# Access Compliance Report

## Public Rights-of-Way

Intersection ID: 49925	Main Street: PAXTON_RUN_RD	Cross Street: CAMPBELL_HALL_CT	Location: SW
ADA ID: 1DE126D0B8F4	Ramp Type: Perp	Initial Pass/Fail: Fail	Overall Compliance: No
Severity Score: 13.75			
Codes/Mitigation Info/Possible Solution		Field Measurements/Component Compliance

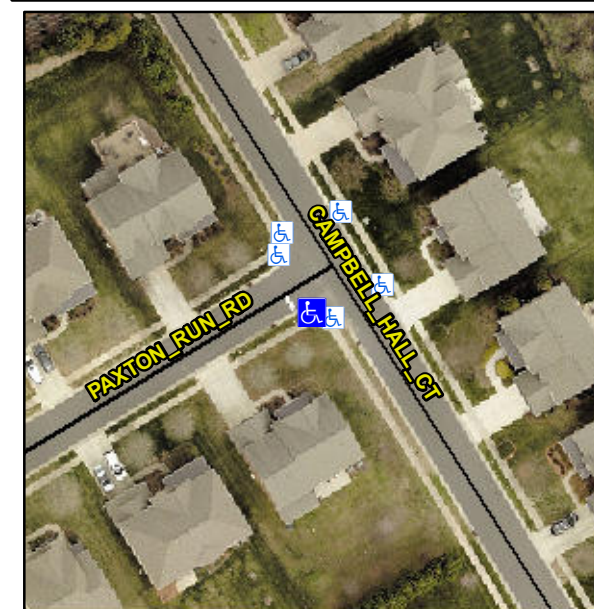
**Not Found, R304.2.2, R304.5.3**

Compliance	Description	Data	Compliance	Description	Data
N/A	Ramp Length (in)	45.0	No	Ramp Slope (%)	9.5
Yes	Ramp Width (in)	48.0	No	Ramp XSlope (%)	2.2
N/A	Flare Type LT	N/A	N/A	Flare Type RT	N/A
N/A	Flare Slope LT (%)	N/A	N/A	Flare Slope RT (%)	N/A
N/A	Flare Traversable LT?	N/A	N/A	Flare Traversable RT?	N/A
N/A	Landing Length (in)	N/A	N/A	DWS Provided?	N/A
N/A	Landing Width (in)	N/A	N/A	DWS Contrast?	N/A
N/A	Landing Slope (%)	N/A	N/A	DWS Length (in)	N/A
N/A	Landing X Slope (%)	N/A	N/A	DWS Full Width?	N/A
N/A	Landing Curb? (Y/N)	N/A	N/A	DWS Offset (in)	N/A
N/A	Shared Landing?	N/A			
N/A	Gutter Ponding?	N/A	N/A	Gutter Slope (%)	N/A
N/A	Gutter Lip Ht (in)	N/A	N/A	Gutter X Slope (%)	N/A
N/A	Painted X Walk1?	No	N/A	Painted X Walk2?	N/A
	X Walk 1 Direction	To NW		X Walk 2 Direction	N/A
N/A	X Walk 1 Width (in)	N/A	N/A	X Walk 2 Width (in)	N/A
	X Walk 1 Slope (%)	0.4		X Walk 2 Slope (%)	N/A
	X Walk 1 X Slope (%)	1.1		X Walk 2 X Slope (%)	N/A

**Remove & Replace Entire Ramp.**
